Access Compliance Report

Public Rights-of-Way

(Curb Ramps)

Intersection ID: 13115	Main Street: S_MINT_ST	Cross Street: WINONA_ST	Location: NW
ADA ID: 445BC6150AA5	Ramp Type: PerpDiag	Initial Pass/Fail: Fail	Overall Compliance: No
Severity Score: 26.25			
Codes/Mitigation Info/Possible Solution		Field Measurements/Component Compliance

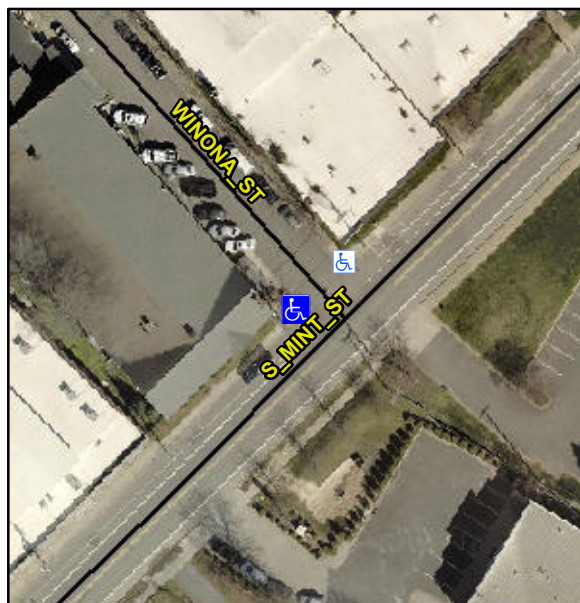
Not Found, R304.2.2, R304.5.3

Compliance	Description	Data	Compliance	Description	Data
N/A	Ramp Length (in)	24.0	No	Ramp Slope (%)	13.3
Yes	Ramp Width (in)	48.0	No	Ramp XSlope (%)	3.1
N/A	Flare Type LT	N/A	N/A	Flare Type RT	N/A
N/A	Flare Slope LT (%)	N/A	N/A	Flare Slope RT (%)	N/A
N/A	Flare Traversable LT?	N/A	N/A	Flare Traversable RT?	N/A
N/A	Landing Length (in)	N/A	N/A	DWS Provided?	N/A
N/A	Landing Width (in)	N/A	N/A	DWS Contrast?	N/A
N/A	Landing Slope (%)	N/A	N/A	DWS Length (in)	N/A
N/A	Landing X Slope (%)	N/A	N/A	DWS Full Width?	N/A
N/A	Landing Curb? (Y/N)	N/A	N/A	DWS Offset (in)	N/A
N/A	Shared Landing?	N/A			
N/A	Gutter Ponding?	N/A	N/A	Gutter Slope (%)	N/A
N/A	Gutter Lip Ht (in)	N/A	N/A	Gutter X Slope (%)	N/A
N/A	Painted X Walk1?	No	N/A	Painted X Walk2?	No
	X Walk 1 Direction	To SE		X Walk 2 Direction	To NE
N/A	X Walk 1 Width (in)	N/A	N/A	X Walk 2 Width (in)	N/A
	X Walk 1 Slope (%)	4.3		X Walk 2 Slope (%)	1.6
	X Walk 1 X Slope (%)	1.1		X Walk 2 X Slope (%)	4.5

N/A	Ramp inside XWalk1?	N/A	N/A	Ramp inside XWalk2?	N/A
	Road Slope (%)	2.2	N/A	Clear Space?	N/A
	Road X Slope (%)	4.2	N/A	Clear Space to XWalk (in)	N/A
N/A	Any Obstructions?	N/A	N/A	Storm Grate/Utility Hazard?	N/A
	Obstruction Type			Storm Grate/Utility Type	
		N/A			N/A
			Yes	Surface Condition? (G/P)	Good

Remove & Replace Curb Ramp With Two New Directional Ramps or Equivalent.
